Re: 1376 Campus Road  
Final Subdivision and Land Development Plan – Phase 3  
Township Permit No. 25-05-FLDP  
LCEC Project No: 25-100

PROJECT TITLE  
1376 CAMPUS ROAD - PHASE 3  
FINAL SUBDIVISION &  
LAND DEVELOPMENT PLAN  
MOUNT JOY TOWNSHIP  
LANCASTER COUNTY, PA

Re: Final Subdivision & Land Development Plan for 1376 Campus Road – Phase 3  
Our File No. 10221-1

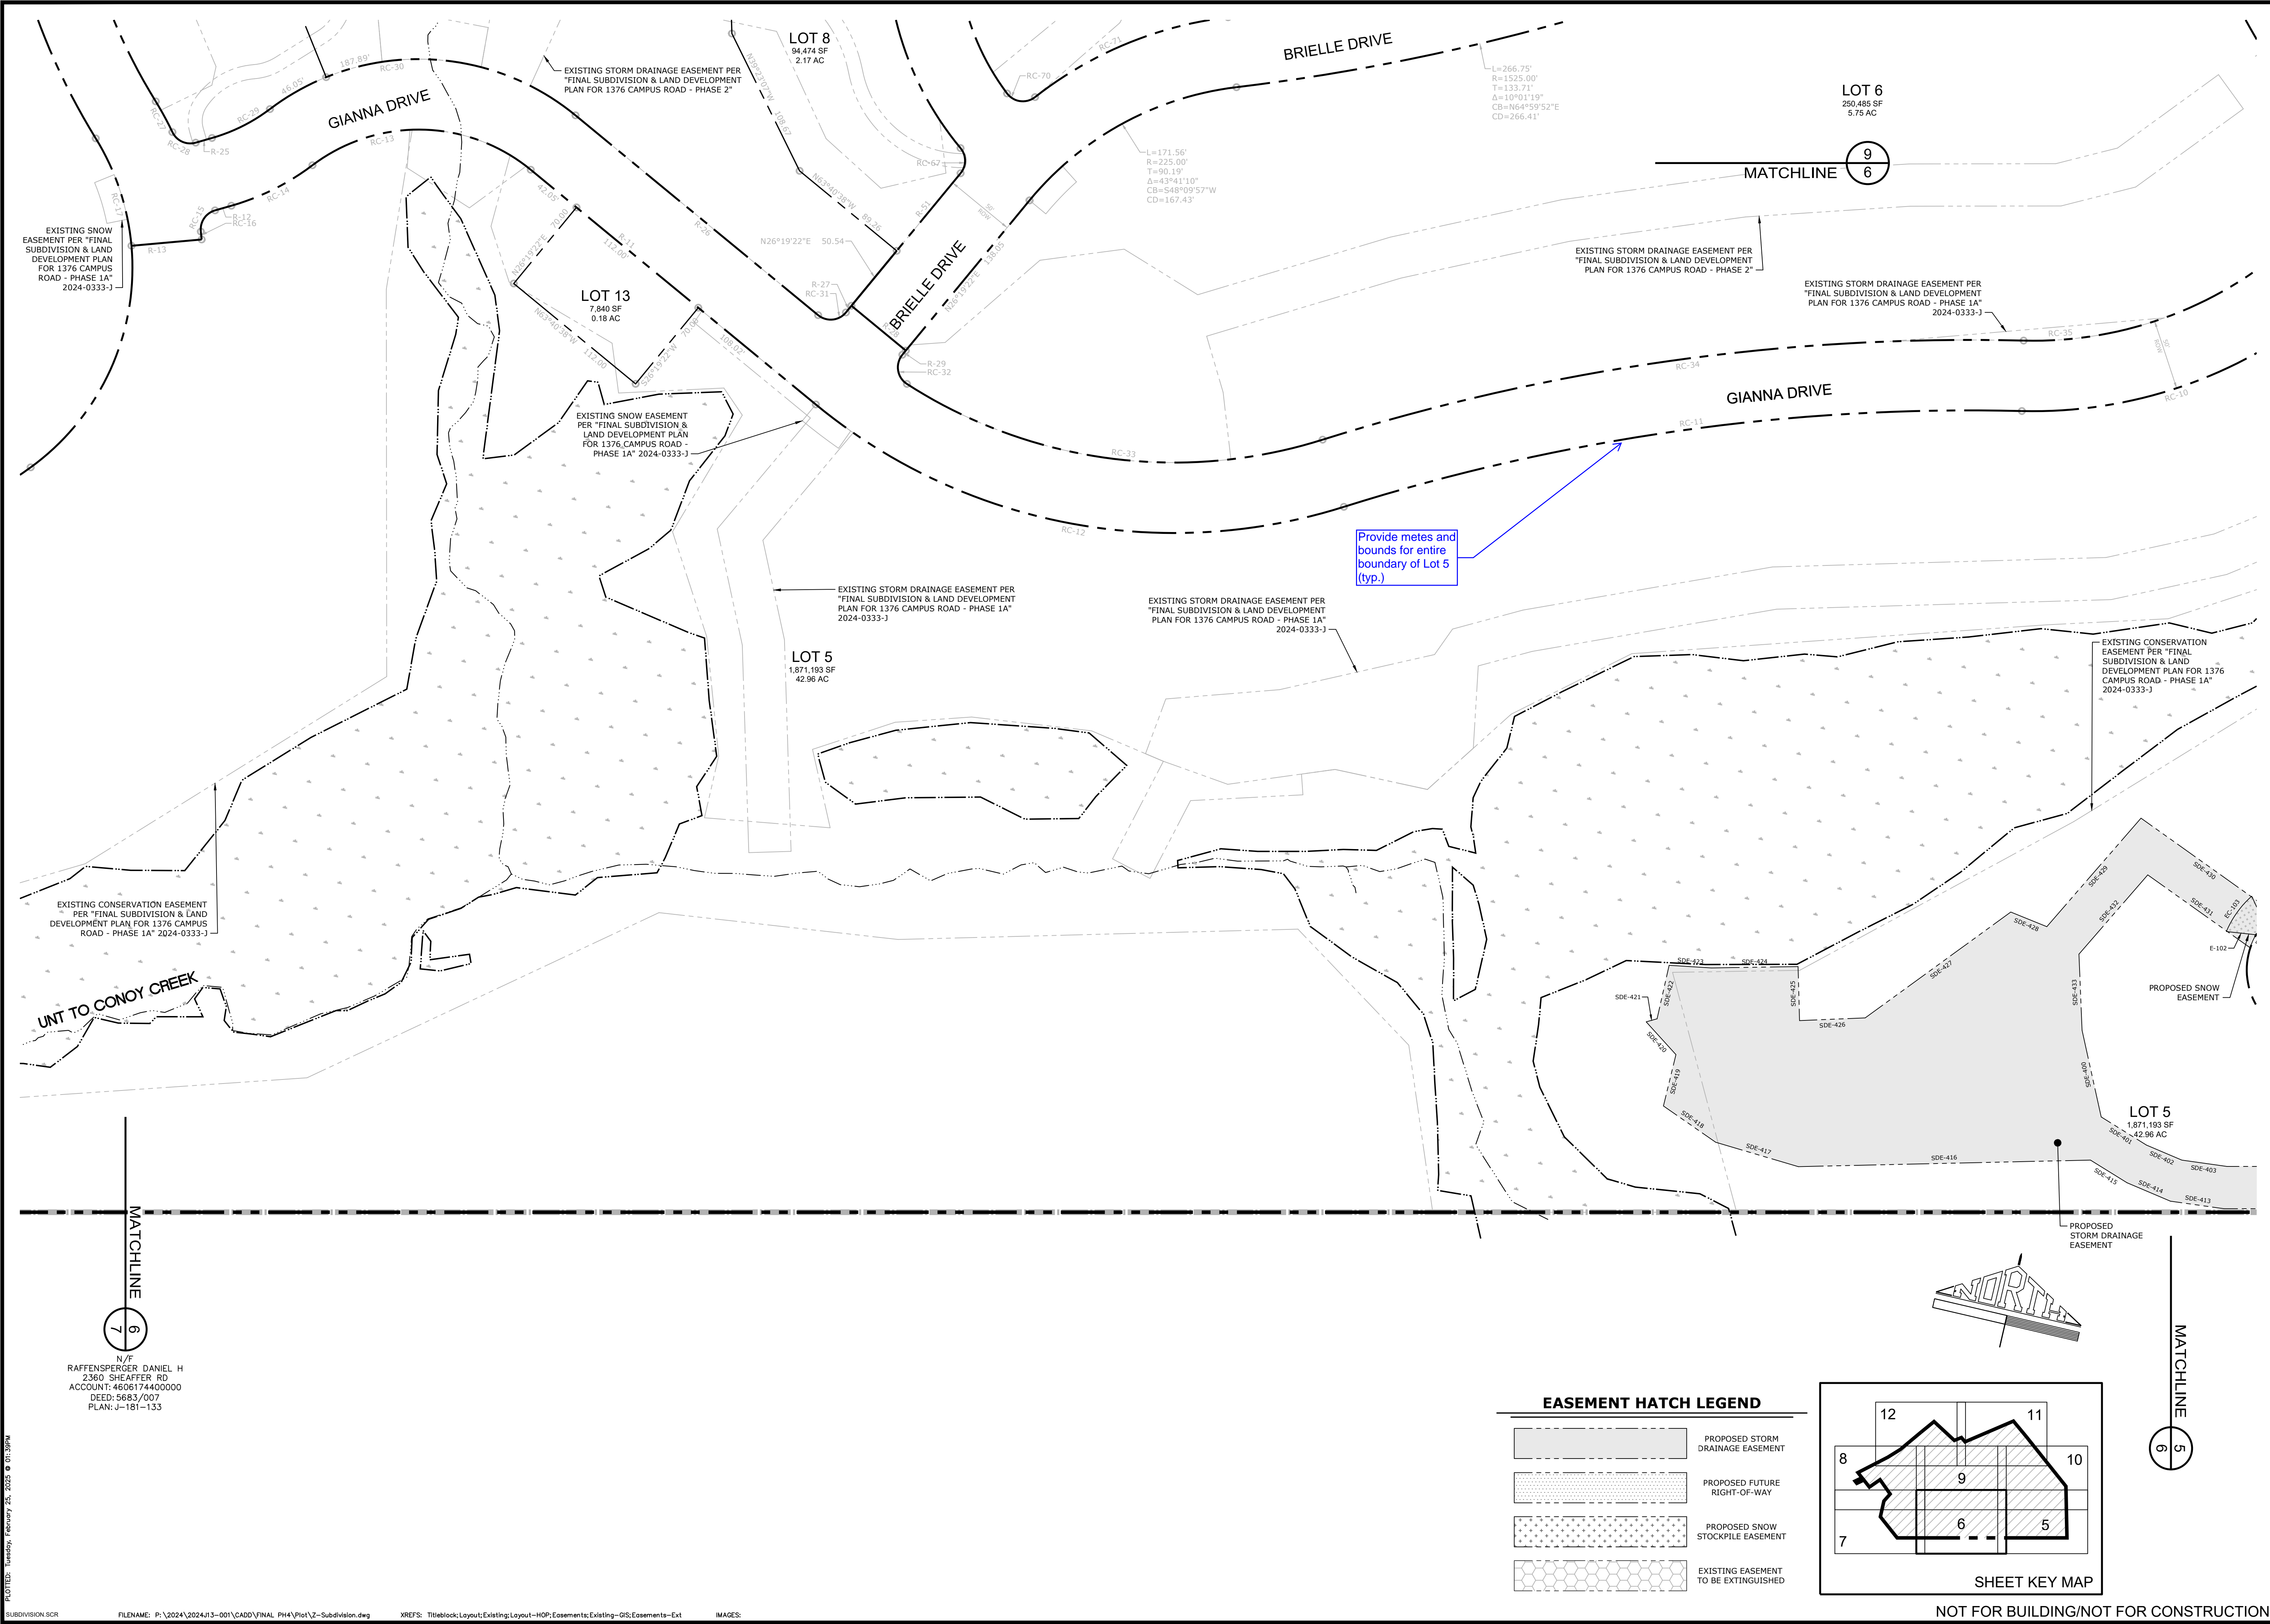
Sheet 5 of the Phase 3 Plan shows numerous snow easements. There will have to be an Agreement Providing for Grant of Road Maintenance Easement to convey these easements to the Township if the Township accepts dedication of the applicable streets. The Township should confirm that the number and location of these easements are acceptable.

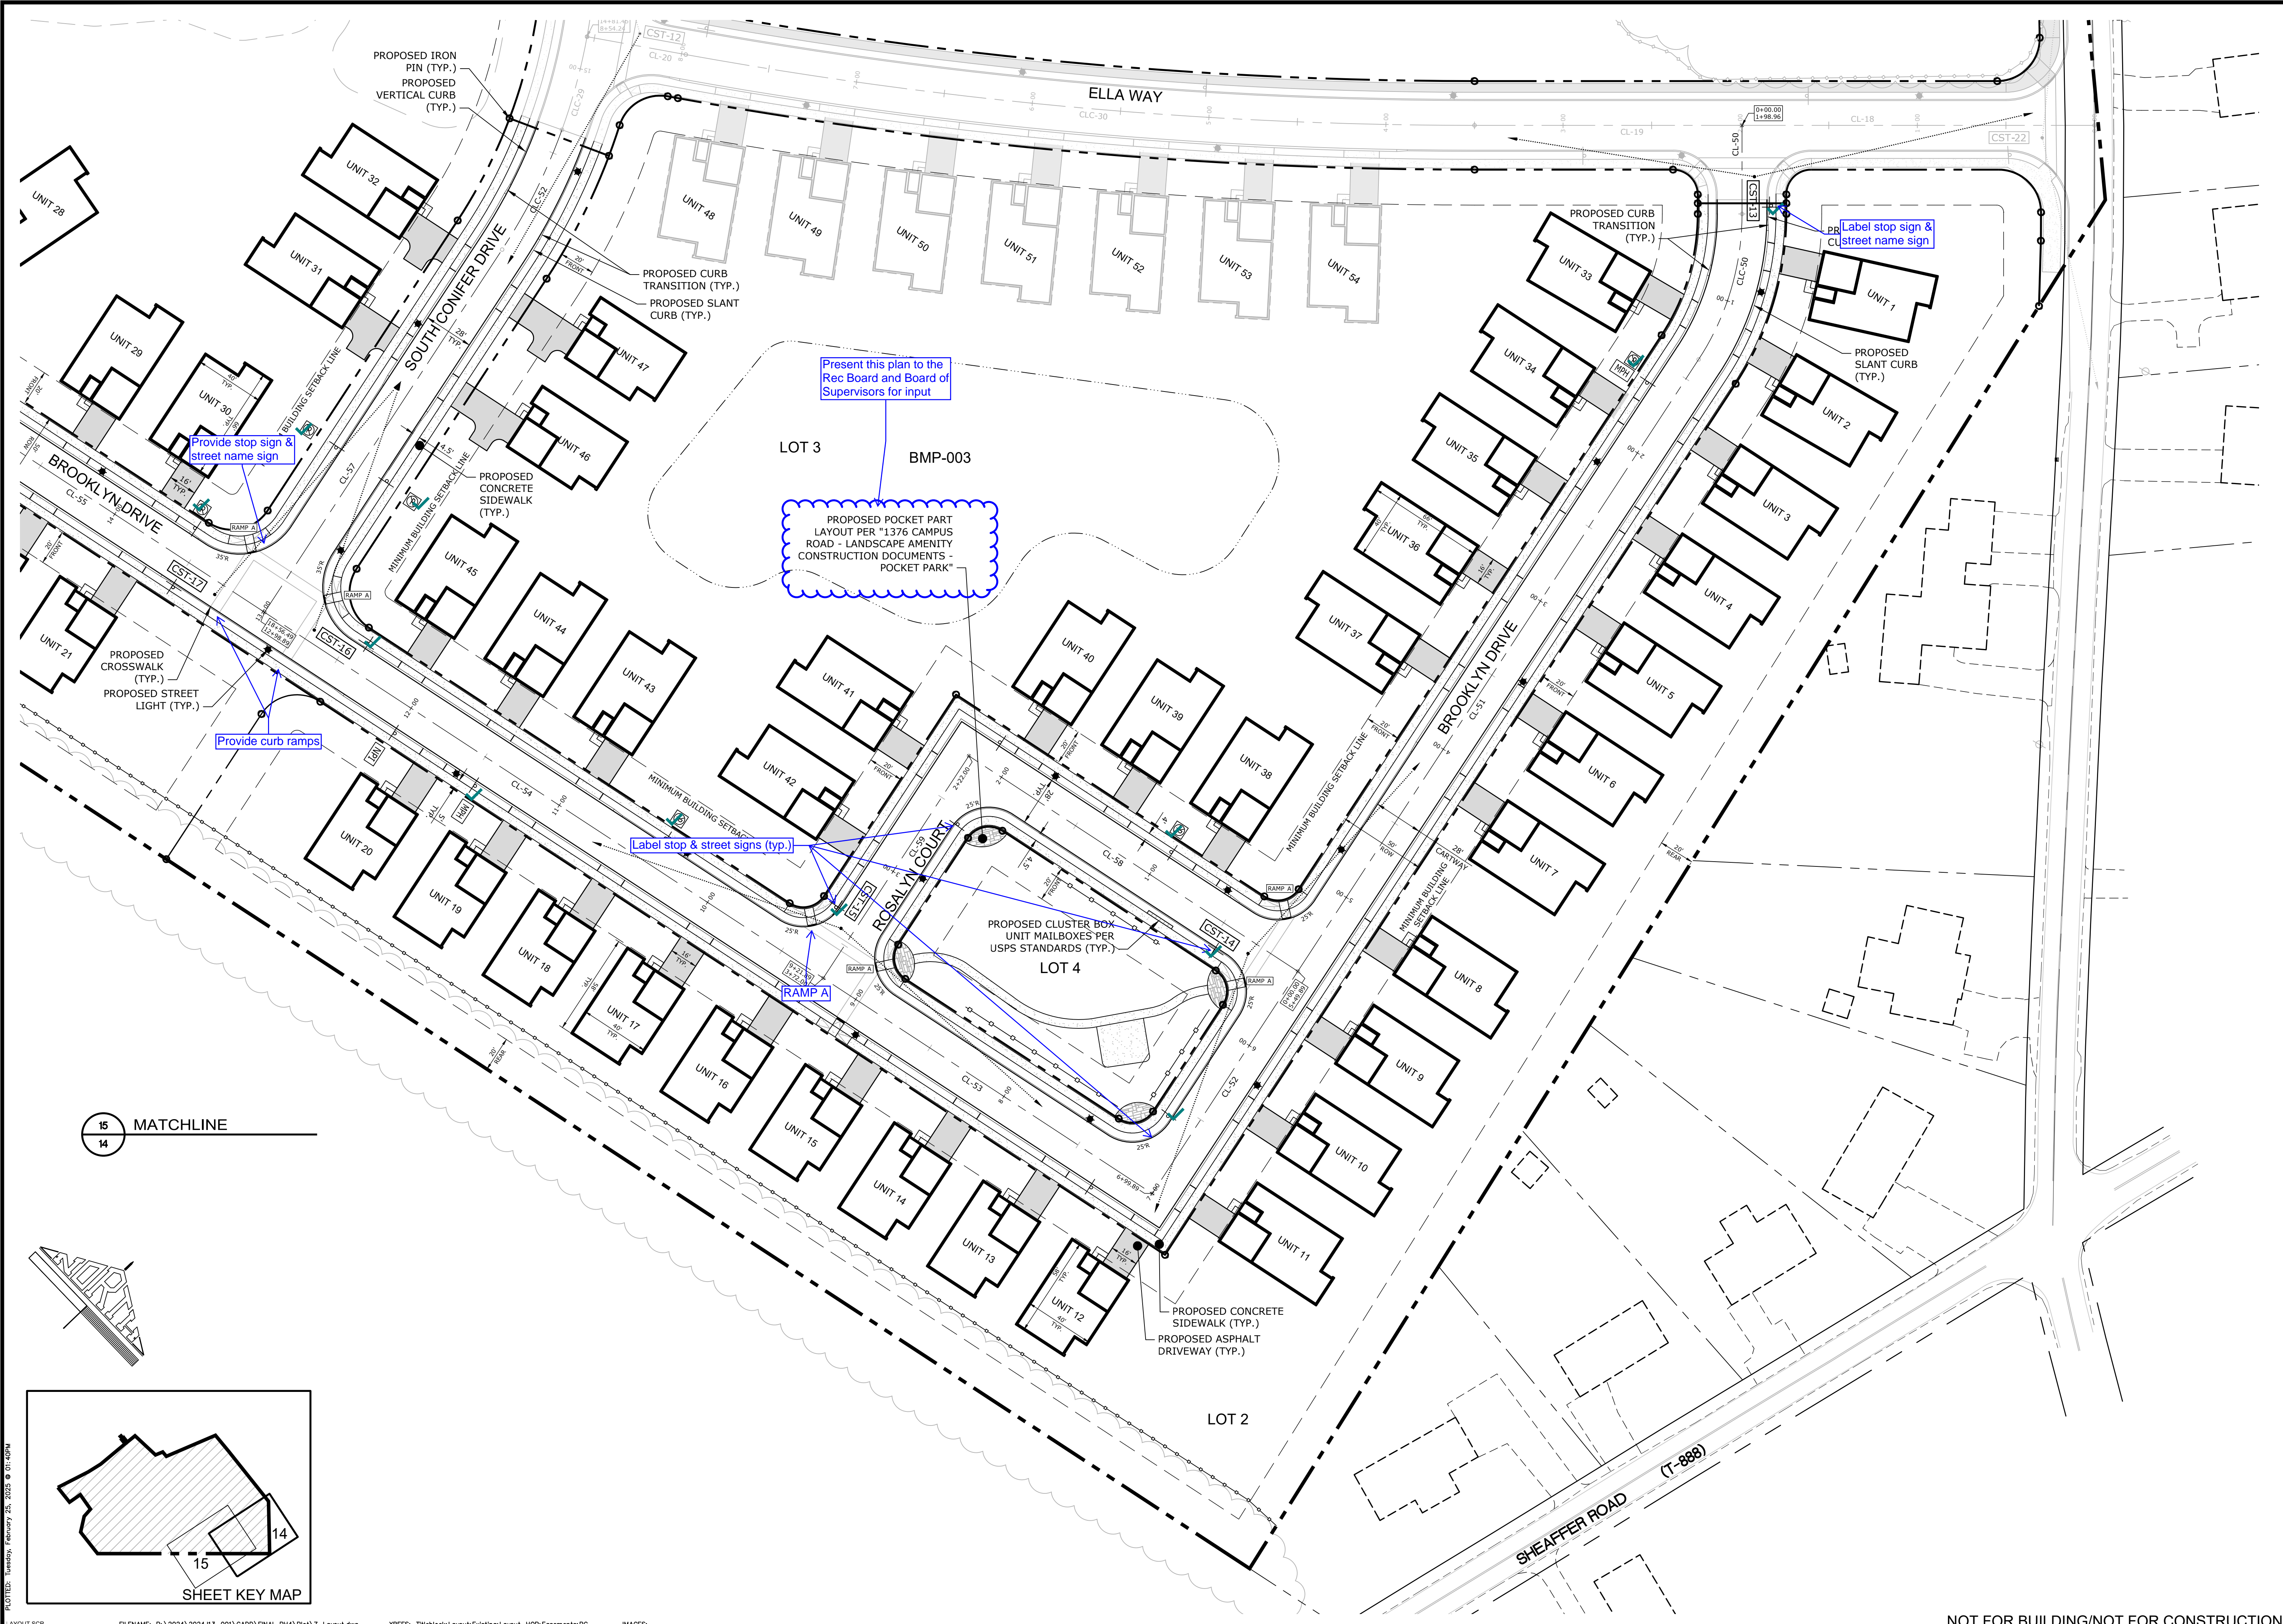
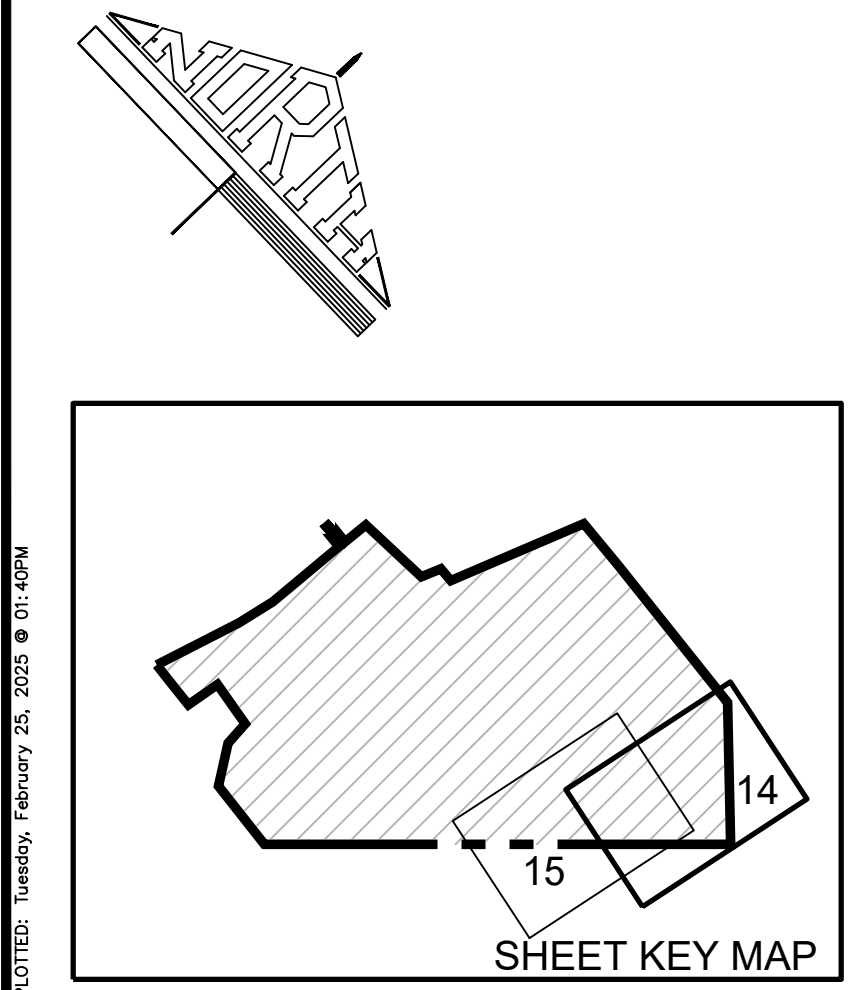
Sheets 14 and 15 of the Phase 3 Plan show an improvement along the tree line at the rear of units 12 through 24 and BMP-001. There is no legend for this item. Is it a permanent or temporary construction fence? If it is a permanent fence, it is located within swales 1 and 2.
